Oregon
Alternate Method Ruling No. 92-25
CEILING "FIRE SEPARATION" DWELLING/GARAGE AND DWELLING/DWELLING
UNDER THE ONE AND TWO FAMILY DWELLING SPECIALTY CODE
(revised 7-15-99, editorial only)

Requested By: Gary Phillips, President, Gary's Vacuflo
December 5, 1991

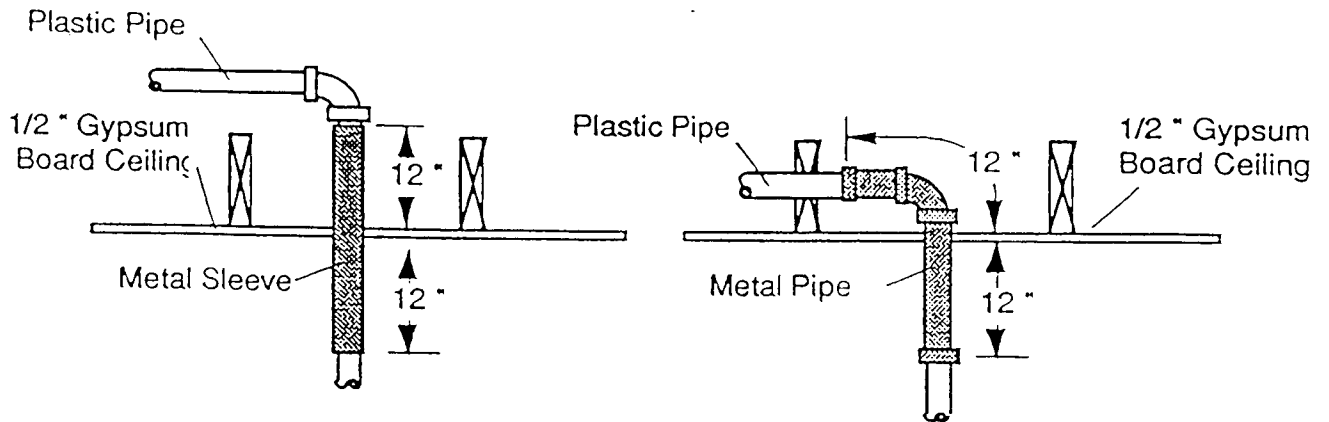
Q 1: What is the extent of the occupancy separation between the dwelling and the garage when such separation is horizontal? May the walls, and any other structural members which support the horizontal ceiling separation, be required to be protected on the garage side?

A1: Where the building layout dictates a horizontal separation in the garage, the walls and any other structural members, which support the horizontal ceiling separation, are not required to be protected on the garage side because there is no code language in the *Dwelling Code* requiring this. If the separation is a floor/ceiling assembly, the structure supporting the assembly shall be protected by ½ inch (12.7mm) gypsum board or equivalent.
